Request for Class II Permissive Change

FCC ID: VG8XM942KYY

Please be notified that we, the undersigned, **Guangdong Midea Kitchen Appliances Manufacturing Co.,Ltd.** declare that the reasons for this class II permissive change are as below:

Original Mother board-top view

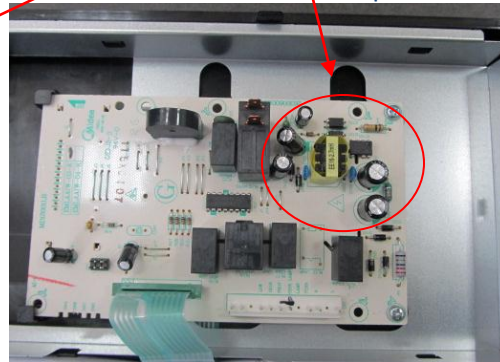
- a) With the same input&output power and similar circuit function.
- b) Changed Linear transformer to switching power supply(see 1).

Original Mother board -bottom

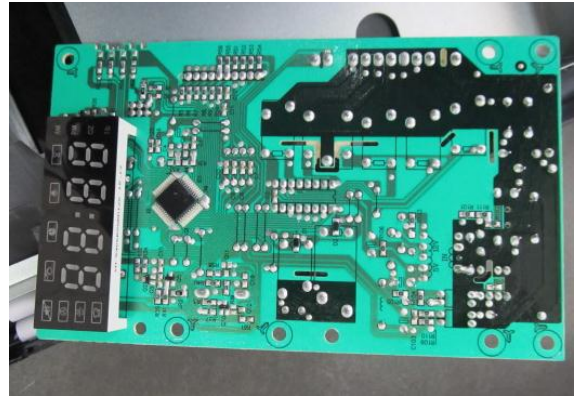
a) Only differences for component and PCB Layout.
